Application No.	Applicant(s)
Notice of Allowability	10/518,578	TAMIS, PAULUS JOZEF
	Examiner	Art Unit
	Stephen F. Gerrity	3721
The MAILING DATE of this communication appears on the cover sheet with the correspondence address All claims being allowable, PROSECUTION ON THE MERITS IS (OR REMAINS) CLOSED in this application. If not included herewith (or previously mailed), a Notice of Allowance (PTOL-85) or other appropriate communication will be mailed in due course. THIS NOTICE OF ALLOWABILITY IS NOT A GRANT OF PATENT RIGHTS. This application is subject to withdrawal from issue at the initiative of the Office or upon petition by the applicant. See 37 CFR 1.313 and MPEP 1308.

## **EXAMINER'S AMENDMENT**

Fig. 2

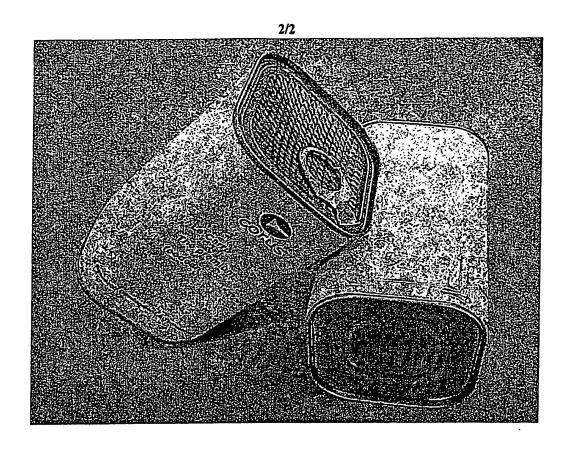
agreed upon by applicant. Figure 2 will be labeled as PRIOR ART. In order to avoid

PRIOR ART
